SEWAGE DISPOSAL SYSTEM

MARYLAND STATE DEPARTMENT OF HEALTH*

ROAD 6548 Montgomery Road LOT 2

SEWAGE DISPOSAL TESTING

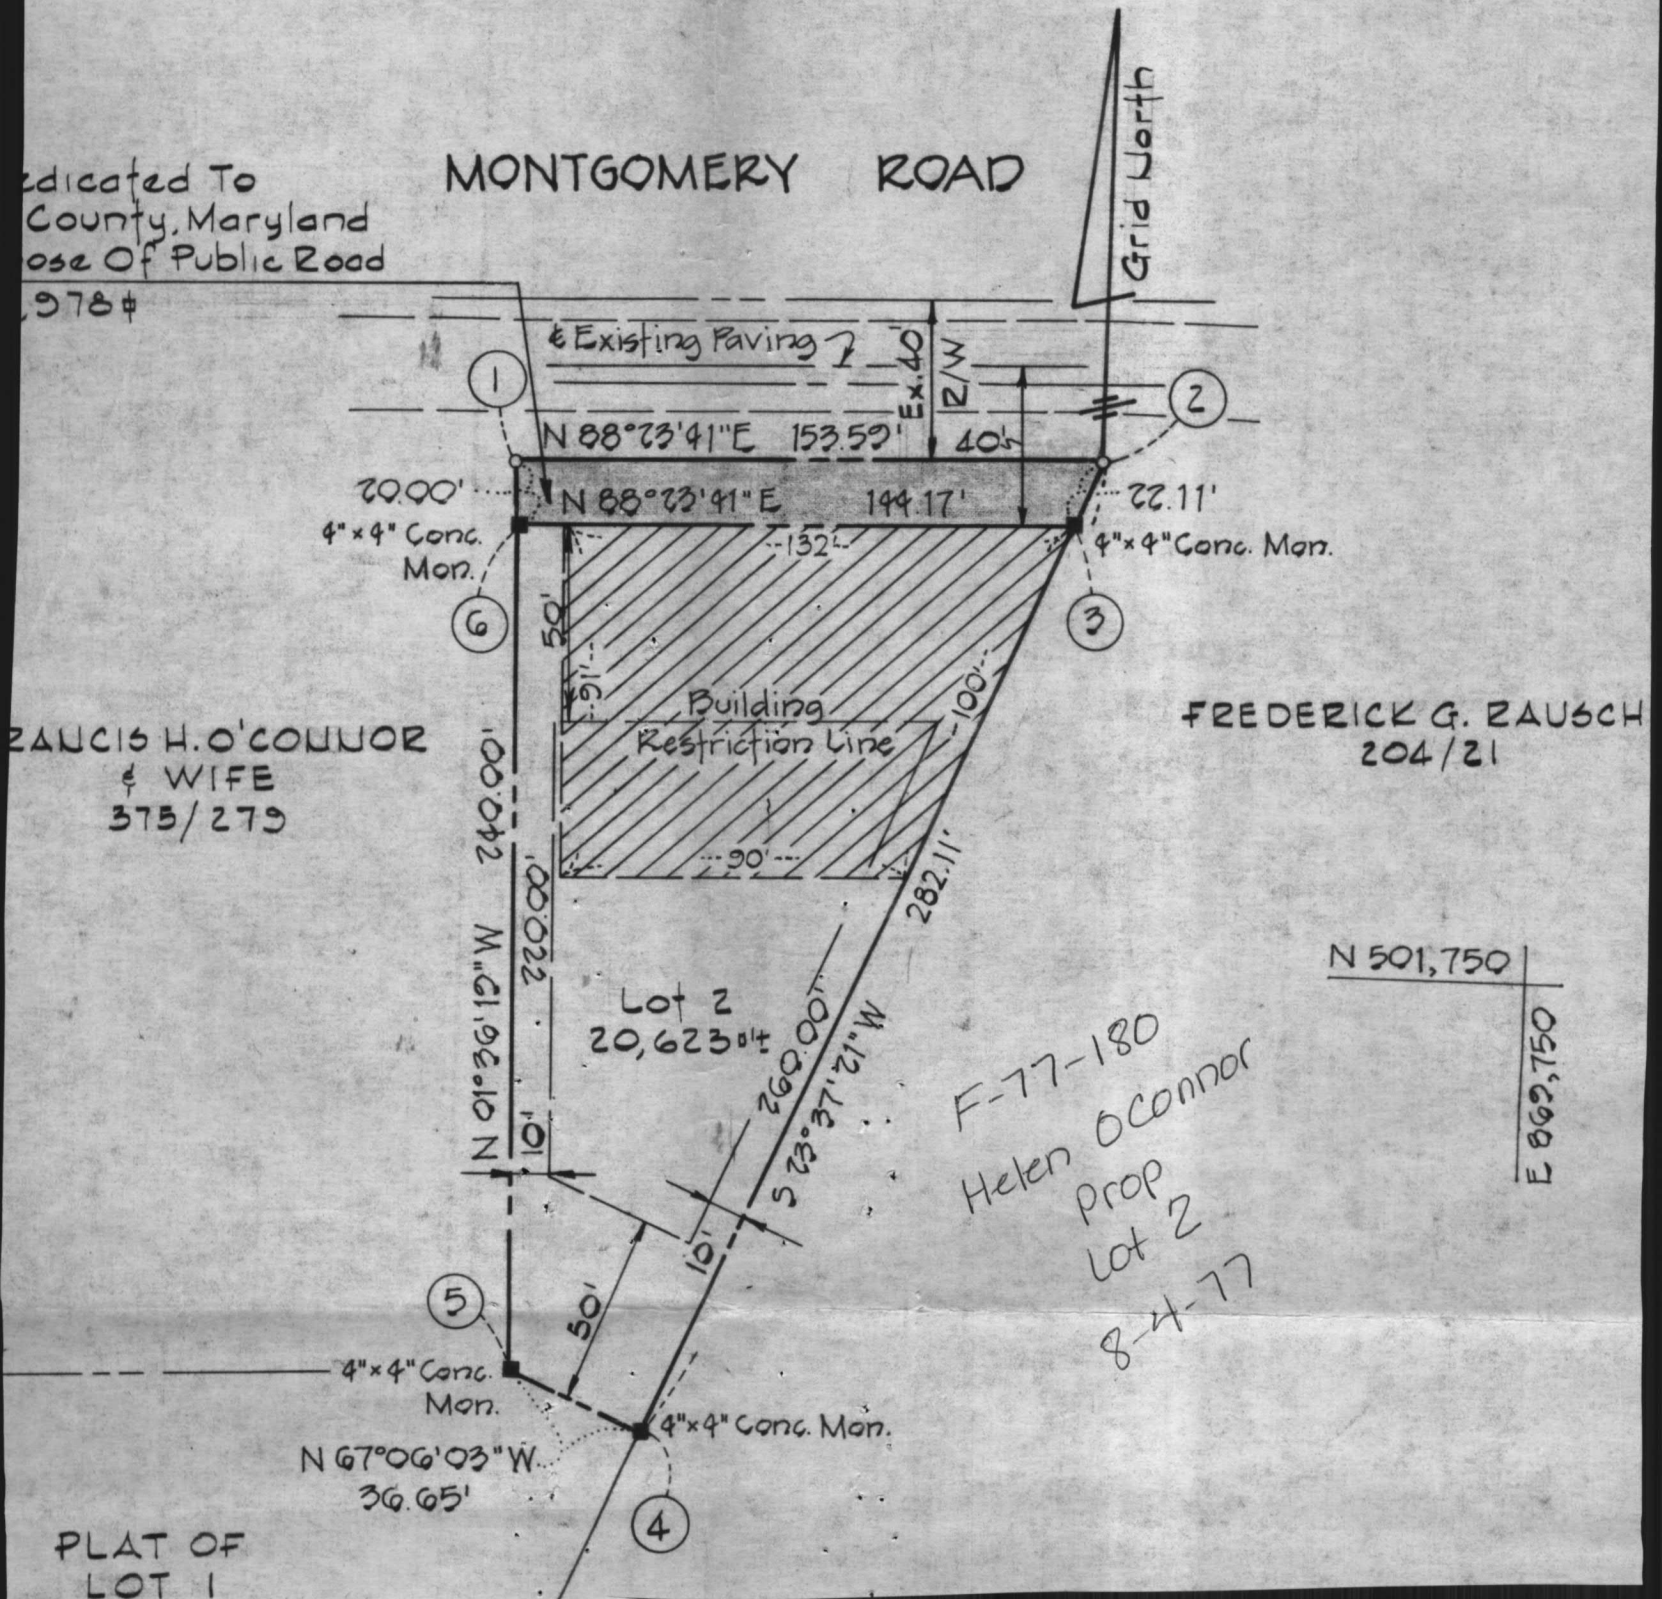
Re 8/16/78 - Reject Plans

① Plans do not show whether the lot or adjacent lots have wells or city water (I think they have city water)

② Plans Do not show the ditch running off the DW
Plans Call for a ditch off DW

③ The septic system for this lot must be installed before Bldg Permit issued
1/16/78

8/17/78 - Discussed Plans with Rayner He is will to do correct plans but wants to start house before septic system must check with DM before exception made so that house can be started before septic system
see other side

OK TO start house
w/ before Septer Syster
installed but
House must be moved
& New Plat submitted
House must be at least
50 FT from Back Line
per zoning requirements
called Rayner

9/5/78 - Ed Burkus met at
office & discussed moving
D.R.Y WELL & House
Closer to Front lot line
I said on this lot that
that was impossible
& House must be 25 ft
from Sewage Disposal Area
& Higher than that area

9/1/78 DM said OK to move house
20 FT down Hill BUT NEW PLANS

8/30/78 OK Revised plan
